Re: Water Treatment Plant – Construction Contingency Expense No. 4

Proposal No. 017 (RFP 012): Filter Slab Modifications:

Request For Proposal No. 012

Re: Filter Slab Modifications

DRAWING
S305

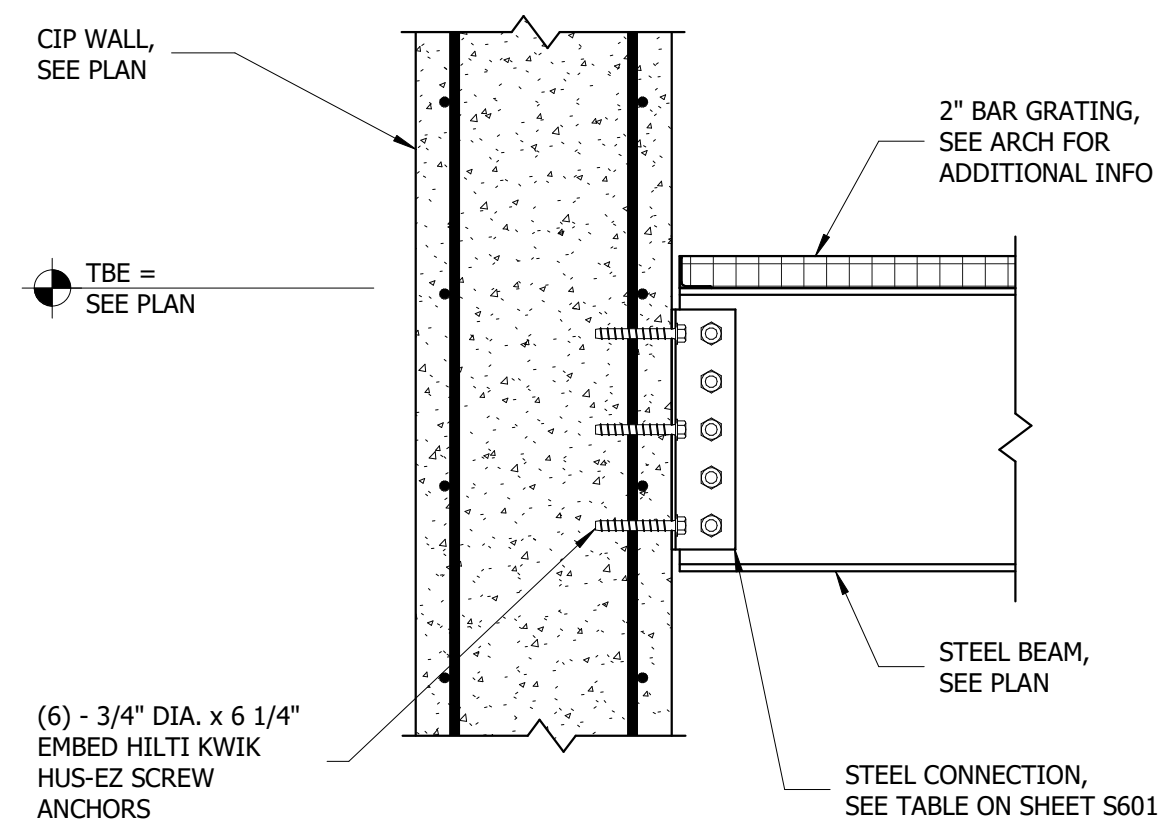
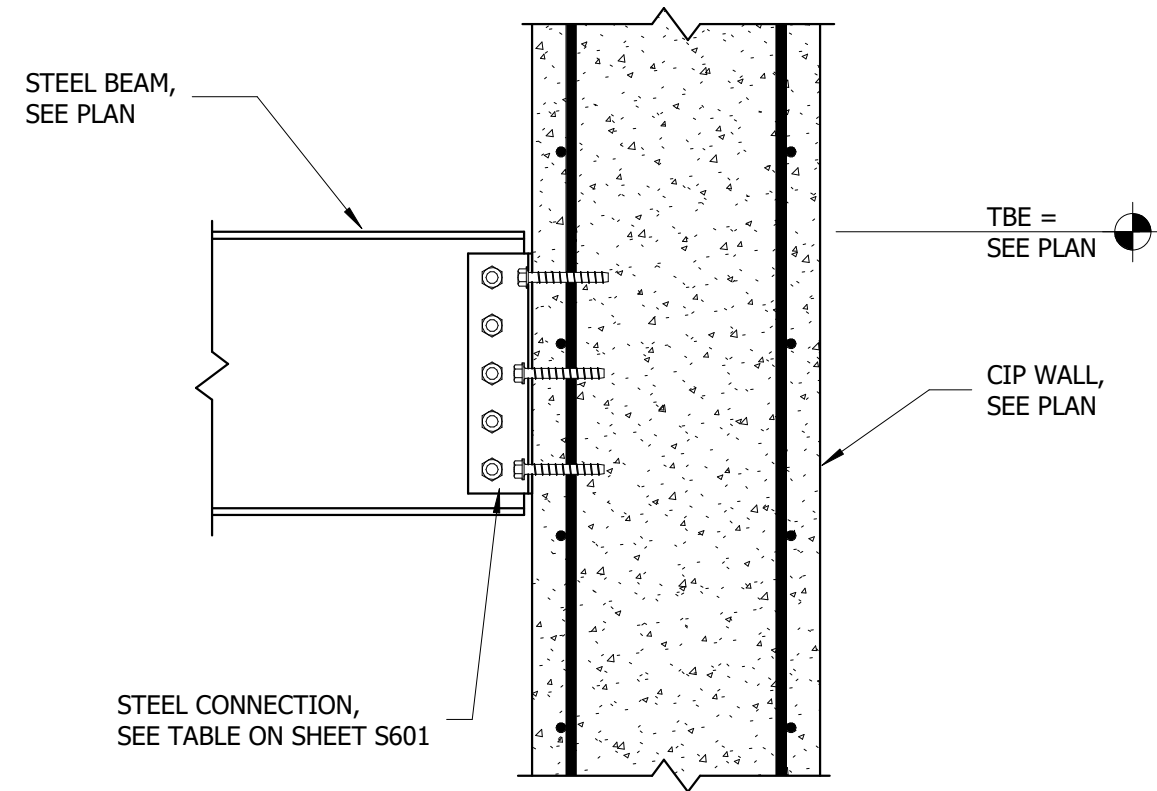
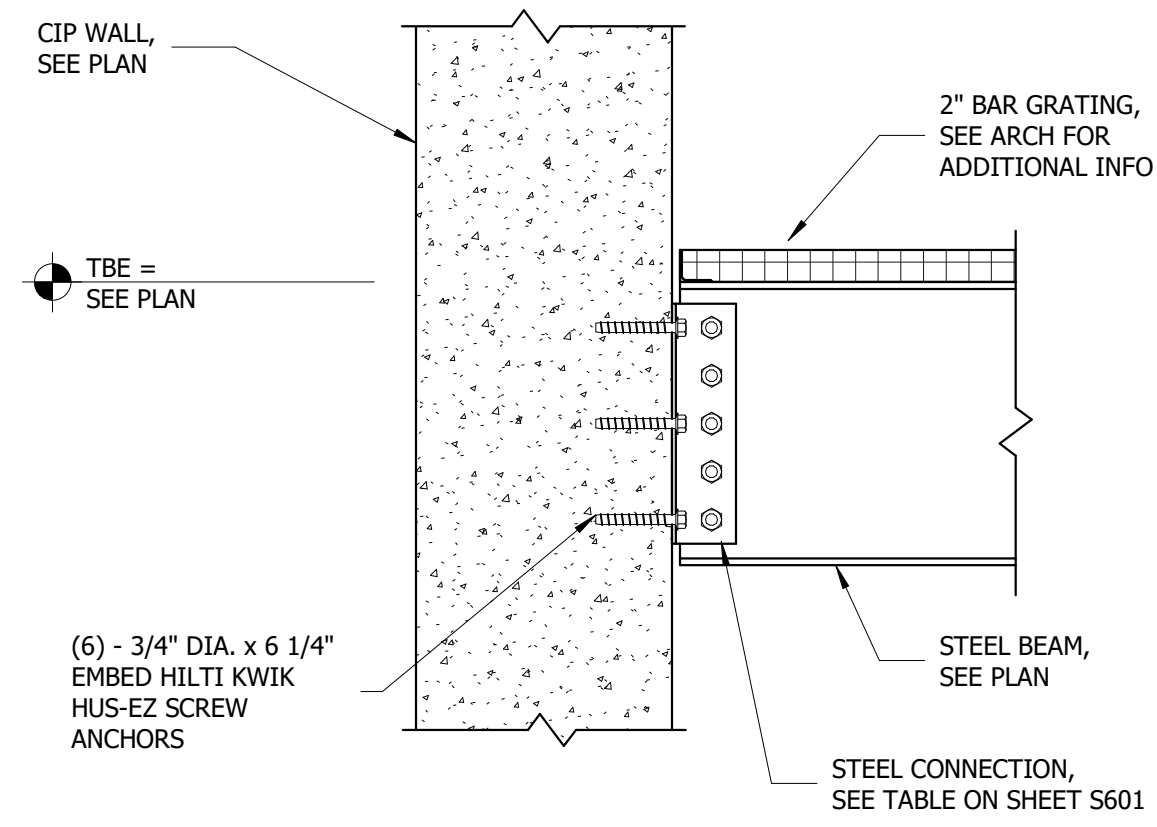
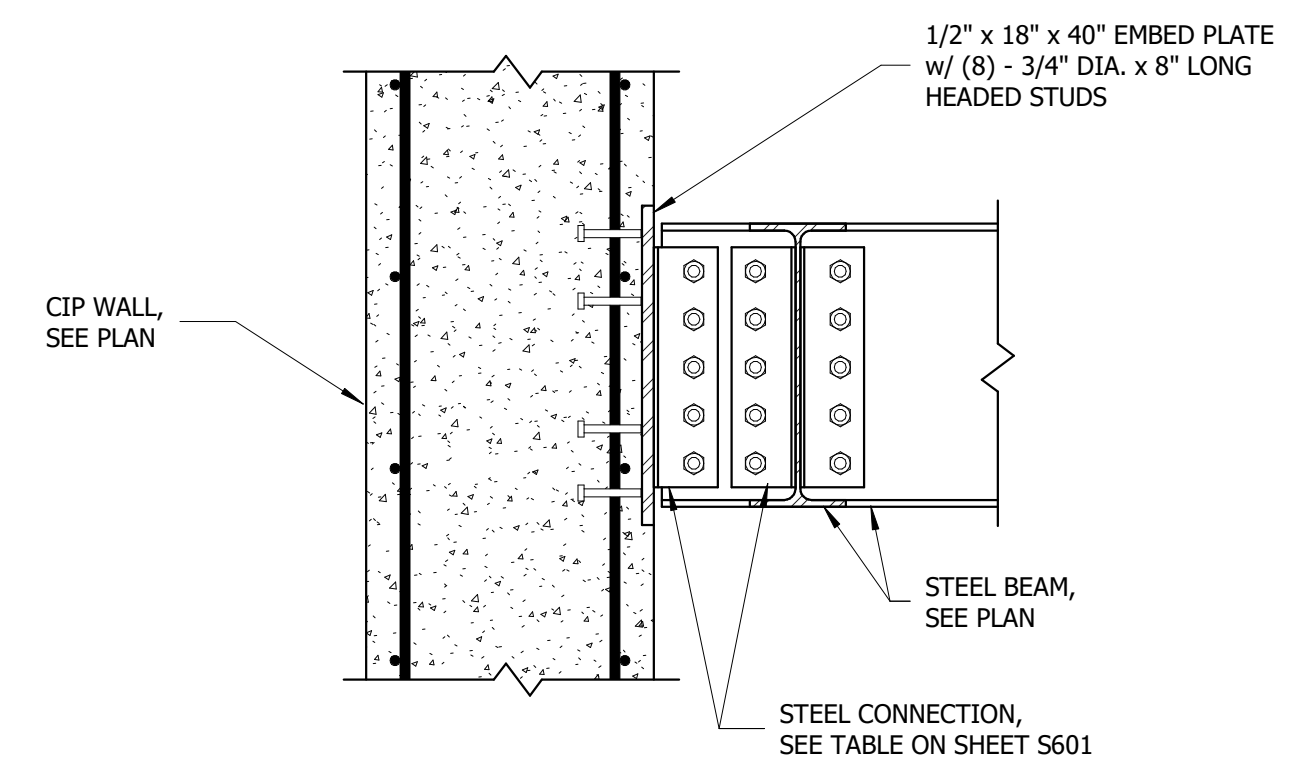
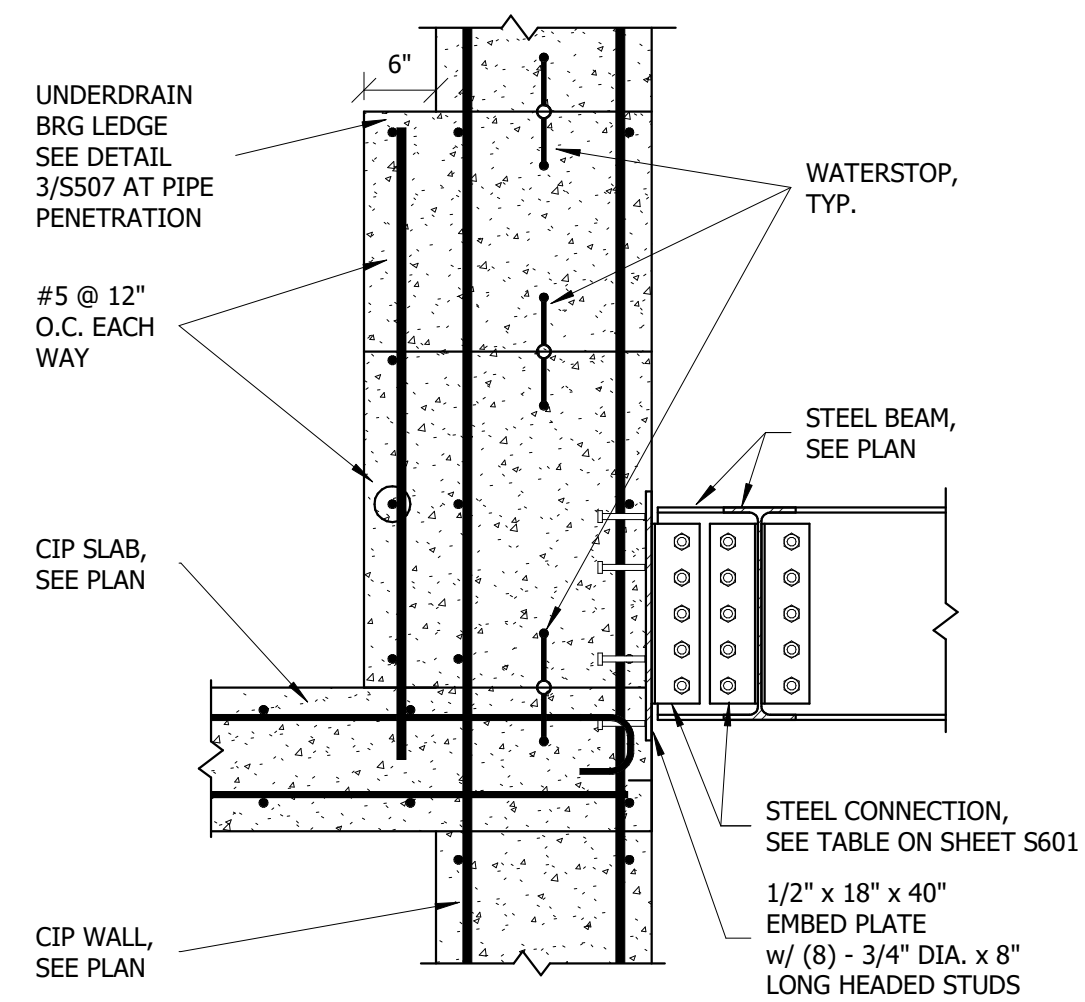
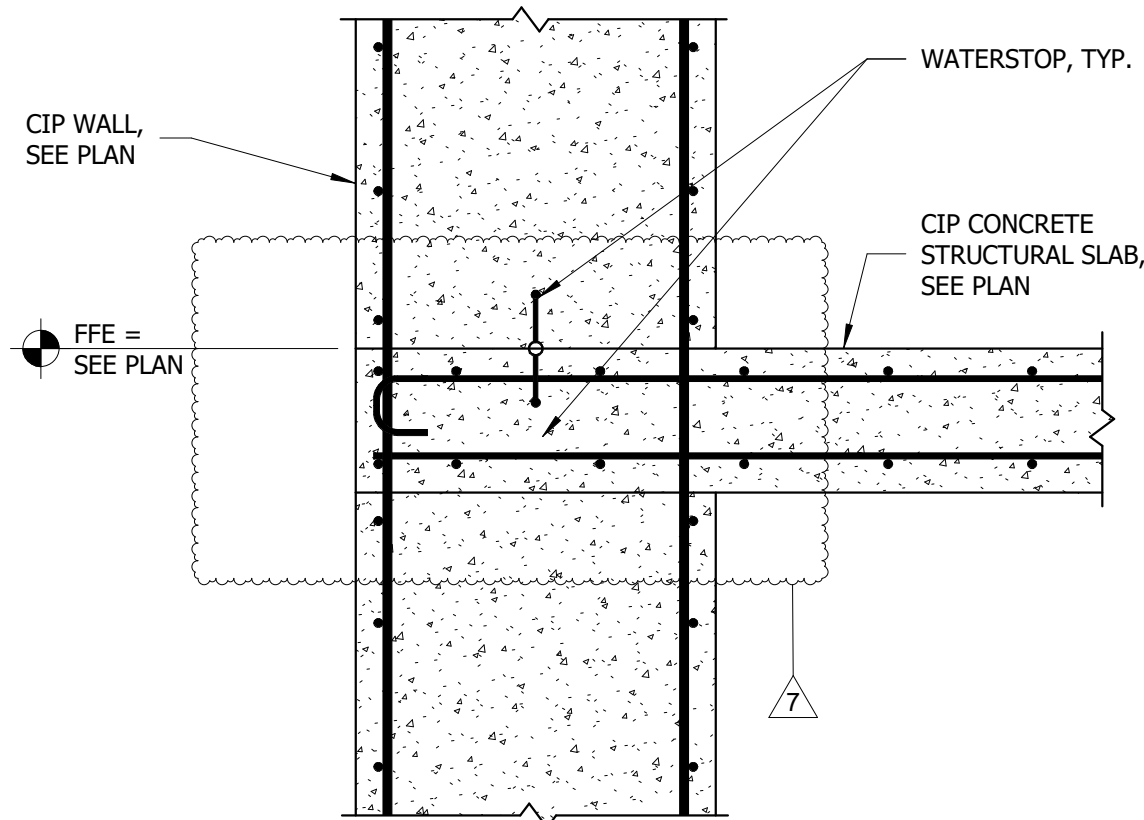
AE2S requests pricing from Magney for changes to the filter slab and CIP supports beams in the clearwell and backwash reclaim tank. Changes include but are not limited to extending the filter slab at elevation 113', increasing the slab thickness to 20" and increasing the CIP beams in the clearwell and backwash tank from 24" to 52". We also request pricing for raising the height of the gullet wall and filter trough to 121'-11". See attached drawings for any additional changes required. Once approved, Contractor will need to resubmit submittal 135 – Concrete reinforcement WTP structural slab, based on provided drawings. See sheets S203, S301, S302, S303, S305, S504, S505 and S601 attached.

Ryan,
Magney Construction, Inc. is pleased to present the following quotation to furnish the necessary labor, material, and equipment to complete the requested changes in RFP 012 - Filter Slab Modifications. To extend and thicken the slab at 113' with required rebar modifications, increase the Clearwell and Backwash beam heights to 52". Along with raising the gullet walls to 121'11". The costs associated with change are summarized below.
